Petition Number: Insert Zoning Petition #2021-023

General Location Identifier: Tax IDs: 22327148, 22327149, 22327150, 22327151, 22327152

Revision Log:	Date	Description	
	02-25-2021	First Review (LJ)

Transportation Summary

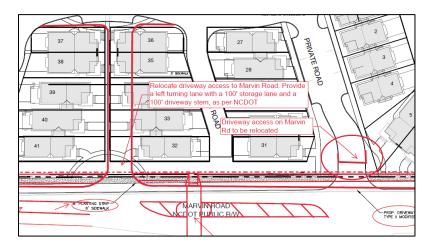
5. Provide a left turn lane on Marvin Road as required by NCDOT. Restripe Marvin Road, per NCDOT Roadway Standard Drawing for PAVEMENT MARKINGS Turn Lanes, 1205.05, to accommodate the left turning lane to include 100' storage.

6. Petitioner will relocate the driveway access point on Marvin Road., as shown per NCDOT, and provide 100' driveway stem.

7. Petitioner will relocate the driveway access point on Old Ardrey Kell Road. The access point with be a RI/RO with a porkchop median and a center median that will begin from the driveway across the street and continue to the end of the Left Turn Lane (LTL) taper to Marvin Road, as shown per NCDOT and provide 100' driveway stem.
